US Army Corps
Of Engineers
St. Paul District

MISSISSIPPI RIVER 9-FOOT CHANNEL PROJECT

POOL 3/UPPER POOL 4

CHANNEL MANAGEMENT STUDY

Figure 1

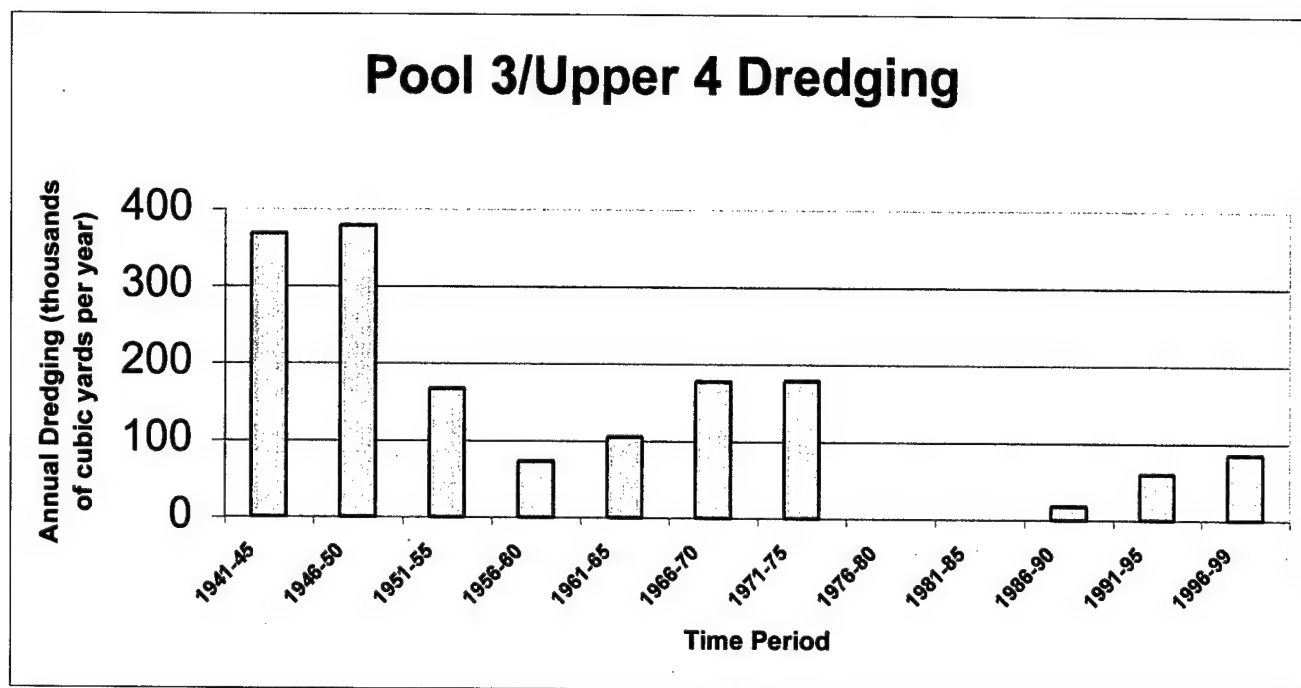
12 | Figure 1, page 5-4, should have an asterisk by the years 1996-98 with an explanation of the higher dredging quantities during those years. The quantities of material dredged in 1998 were higher than normal because the contractor cleaned out the channel during the process of unloading Corps Island. I believe 120,000 cubic yards was taken out of the channel in 1998 and even though minimal depth dredging was the normal during the last several years, this amount was in excess of what would typically be dredged to maintain the nine-foot channel.
